NUREG/CR-4142
UCID-20330

A Review of the Millstone 3 Probabilistic Safety Study

A. A. Garcia, D. L. Bernreuter, T. E. McKone, P. D. Smith (LLNL), P. J. Amico (Applied Risk Technology Corporation), J. W. Reed, M. W. McCann, Jr. (Jack R. Benjamin & Associates, Inc.), P. R. Davis and G. Apostolakis (Consultants)

Prepared for
U.S. Nuclear Regulatory Commission

Fig. A-1 Possible ground motion models for the Eastern United States.

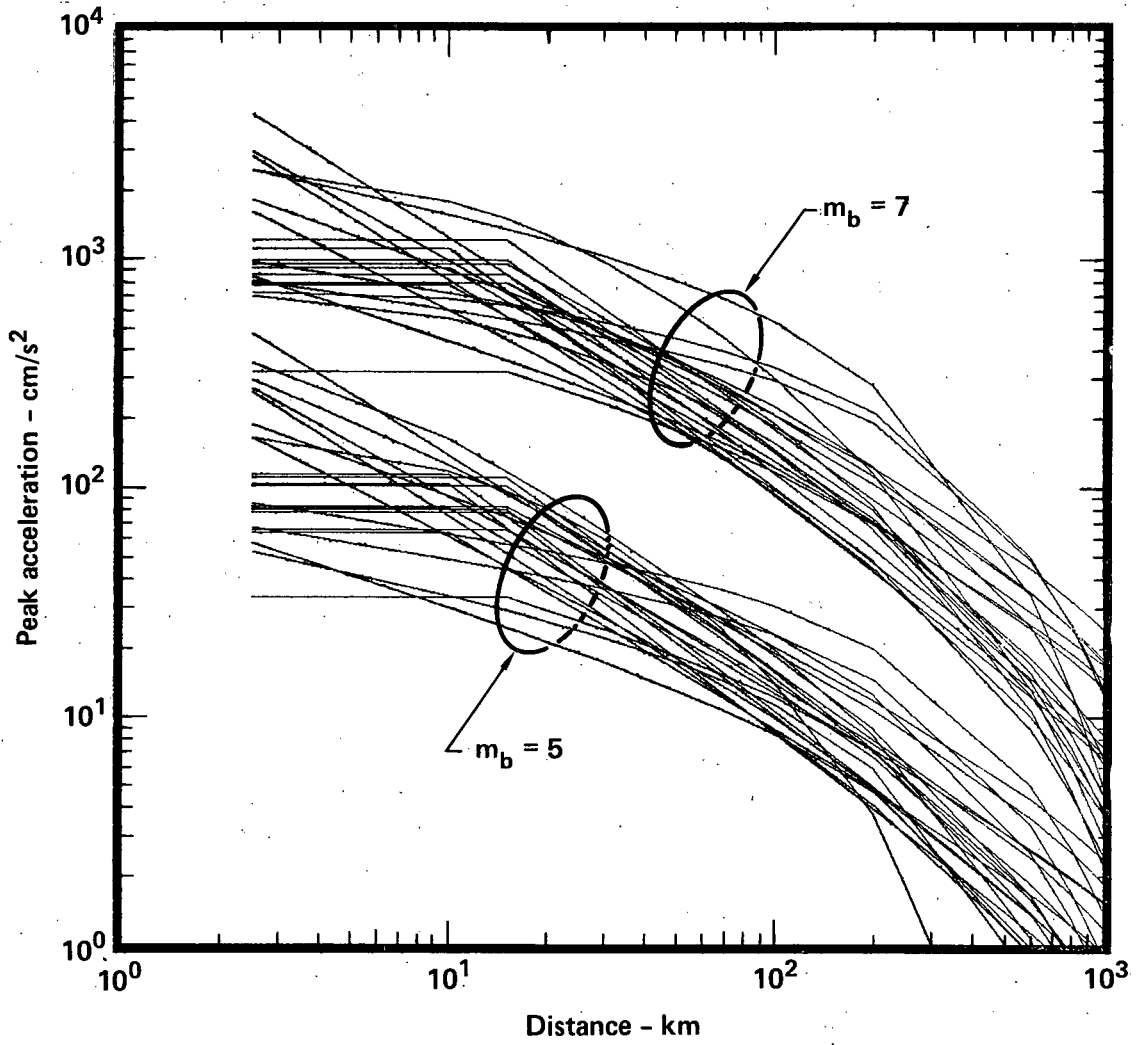
motion models (Ref. A-1) were used. Fig. A-1 shows a comparison of the results from a wide variety of models that use various acceptable alternatives. By acceptable, we mean that the methodology/data used to arrive at the model is reasonable and (at least for the set of models compared in Fig. A-1) at least one member of a panel of experts in modeling of EUS ground motion deemed the model a possible alternative. See Ref. A-5 for further discussion. This figure, which shows peak ground acceleration versus epicentral distance for the magnitude values of 5 and 7, illustrates that there is considerable uncertainty in the ground motion modeling process and supports the point that the $\pm 20\%$ factor used in the D&M analysis is low. The models used in the D&M study are, in our opinion, two of the "better" EUS ground motion models. But as noted in Section A.3, one element of a probabilistic analysis is to ensure that the uncertainty has been bounded and included in the analysis. This has not been accomplished in the D&M selection of ground motion models.

Fig. A-3 Comparison of hazard curves generated by SEP experts, D&M, and USGS approaches.

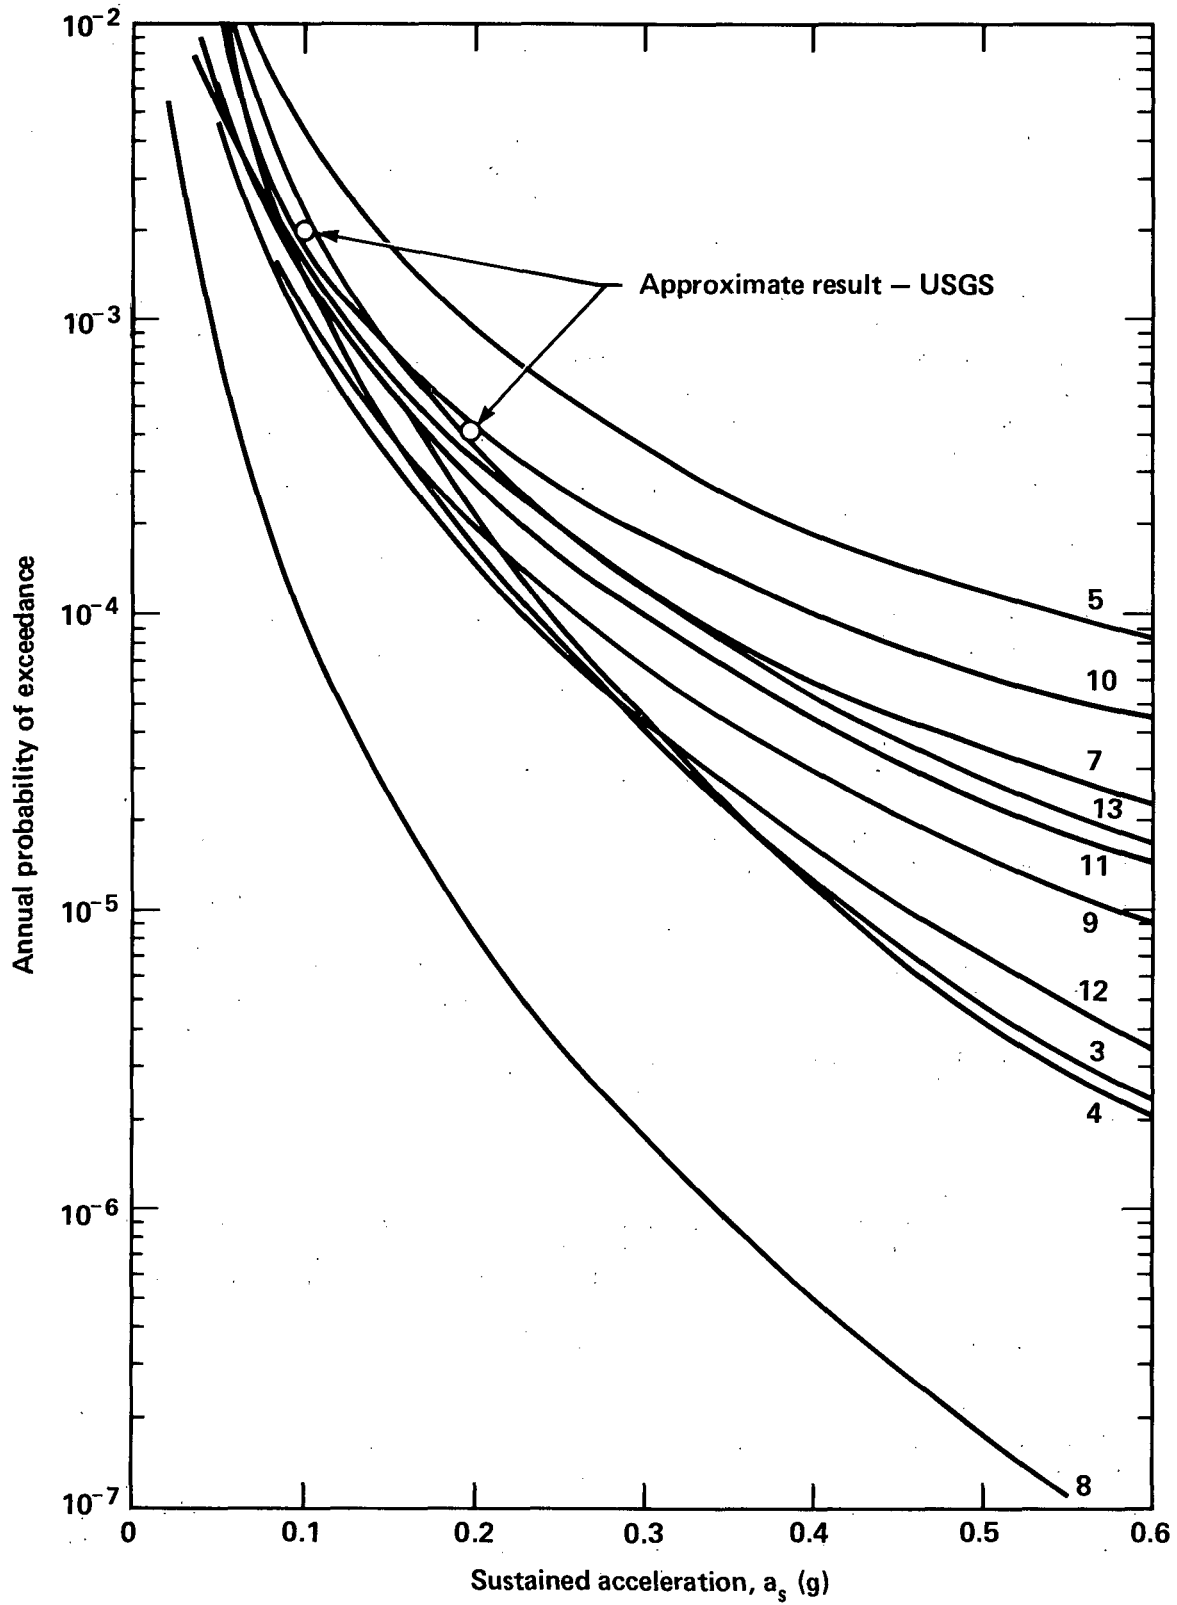
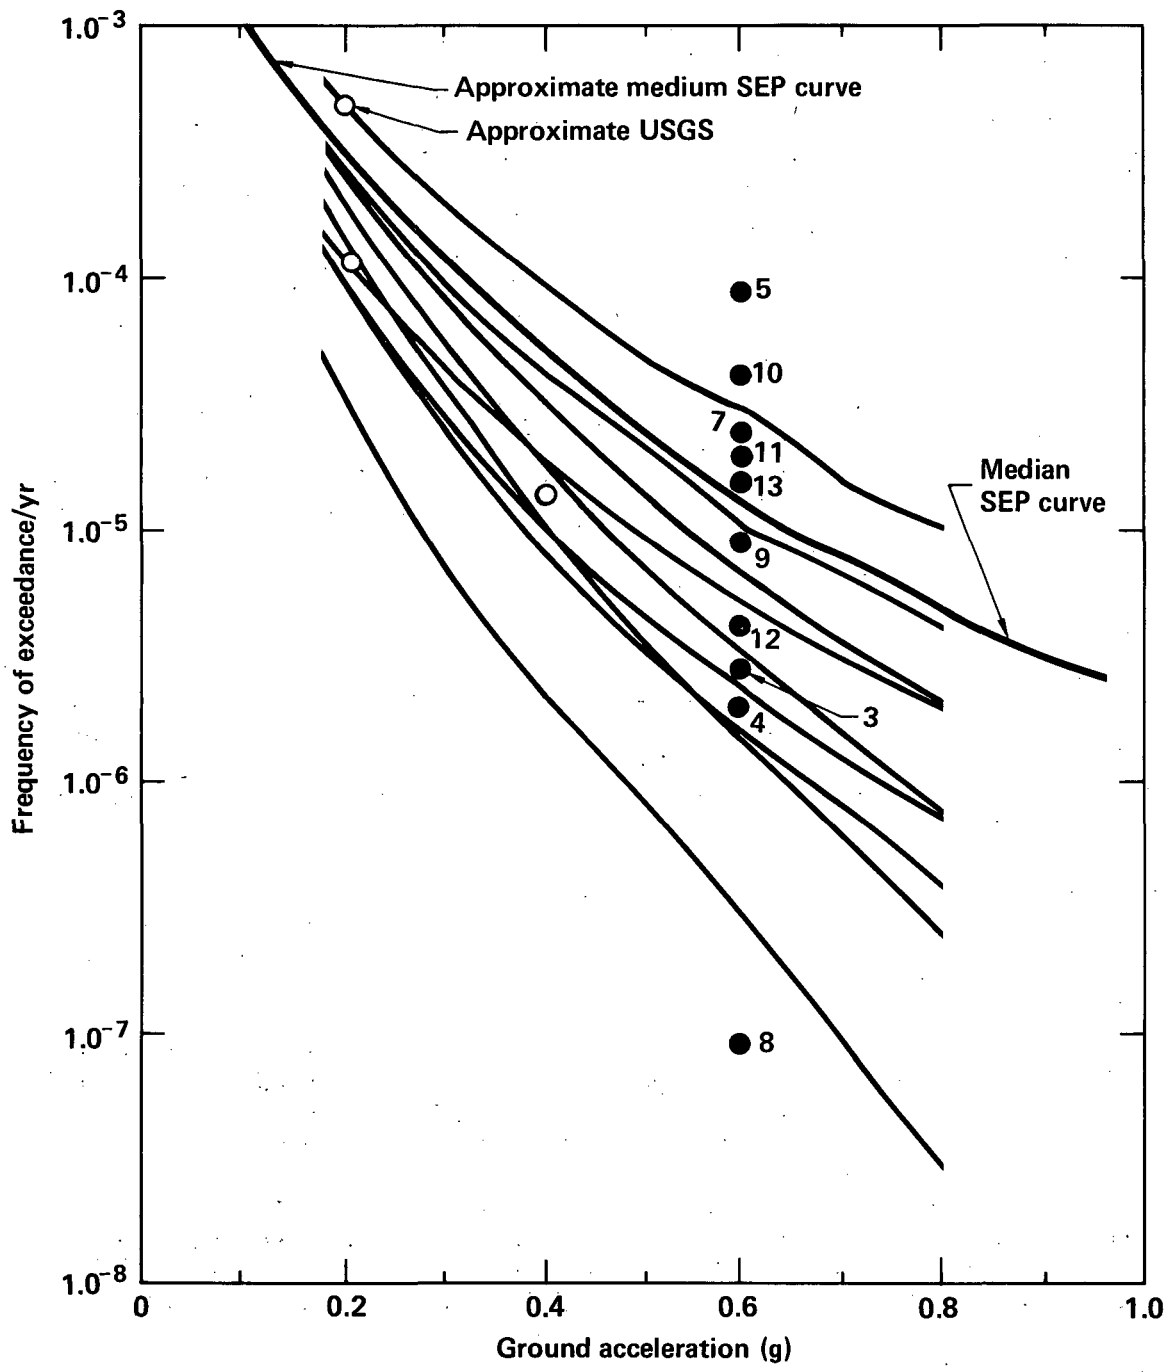
Figure A-2 is a plot of the resulting hazard curves for all the SEP seismicity experts. This figure also shows two points for approximate "sustained" acceleration estimated from the maps in the USGS report by Algermissen, et al. It is seen that the USGS results are in reasonable agreement with the results obtained using the SEP seismicity experts' models. It must be noted that the USGS study used a significantly different ground motion model. It is difficult to assess exactly what hazard curve would be obtained from the USGS study if they had used the same ground motion model utilized in our study. It is most likely that the resulting hazard curve would be higher because no random uncertainty was used in the USGS model. In addition, (Ref. A-5), compares the preliminary results from a new panel of experts to the results obtained for the SEP study. The agreement between these two studies is excellent.

Figure A-3 shows the median curve from Fig. A-2 plotted on PSS Fig. 1.2.1-1. Also shown is the spread of our curves at 0.6g from Fig. A-2. It is seen from this figure that the D&M results are within the spread of the SEP results, but on the low side. It is not possible to determine exactly where the D&M median curve lies relative to the SEP and USGS results because the D&M curves are not equally weighted and the probabilities are not given on the various hazard curves. The D&M median appears to be about a factor of 5 low compared to the SEP median. A reasonably complete uncertainty analysis would spread out the scatter in the curves even more. However, this increase in uncertainty in the seismic hazard is considered unlikely to have much effect on the median curve. But it could have significant effect on the risk as it is generally found in such analyses that an increase in uncertainty increases the risk.

FIGURE 2-1. MILLSTONE RESPONSE SPECTRA FOR 10% DAMPING

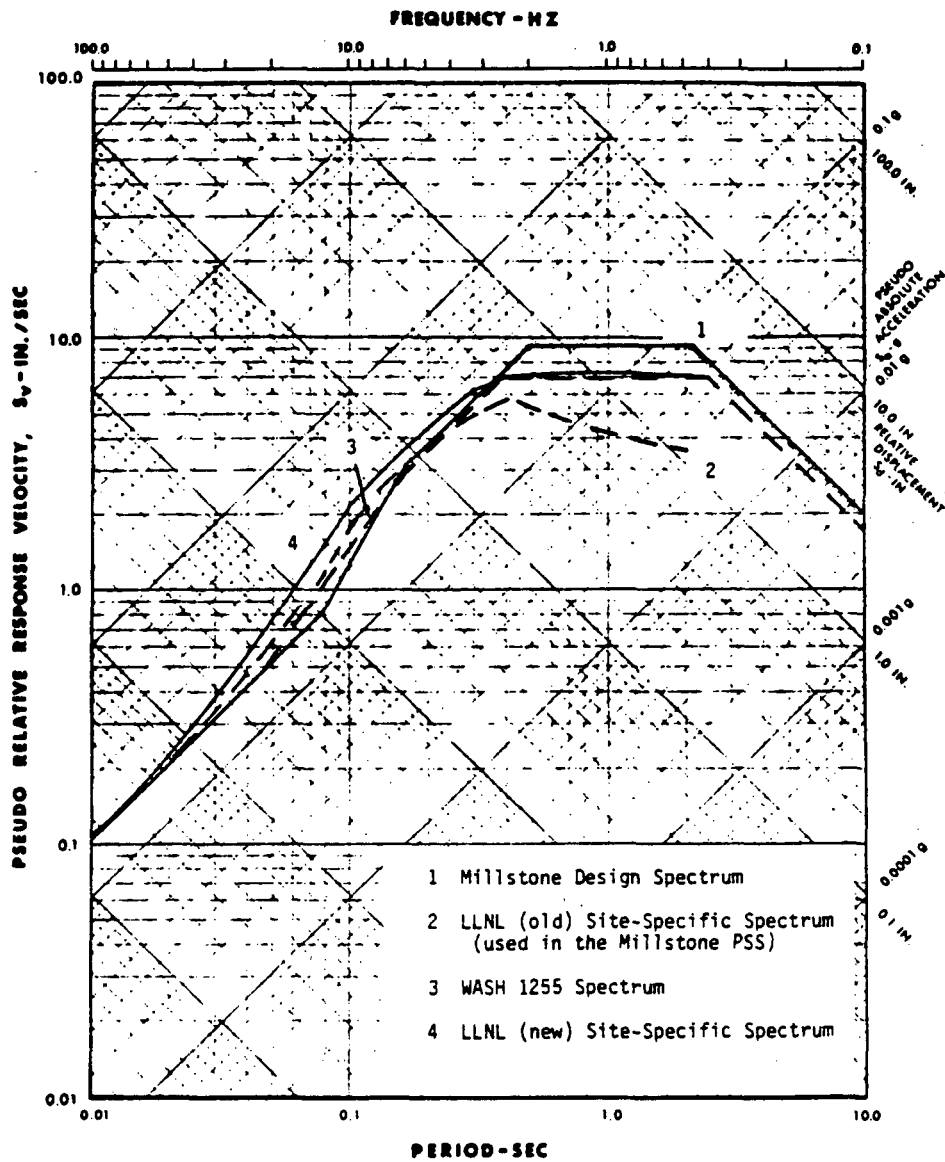
Based on the comparison in Figure 2-1 we find that the magnitude-dependent spectra are generally higher than the design spectra for frequencies greater than 5 Hz. Among these, the most recent spectra developed by LLNL has the highest spectral level. At frequencies less than 5 Hz, the design spectrum exceeds the site-specific spectrum, with the greatest variations occurring at frequencies less than 2 Hz.

4. The NRC should determine if the site-specific spectrum used in the fragility analysis is appropriate. See Table 2-1 and Figure 2-1 for a comparison of different response spectra.
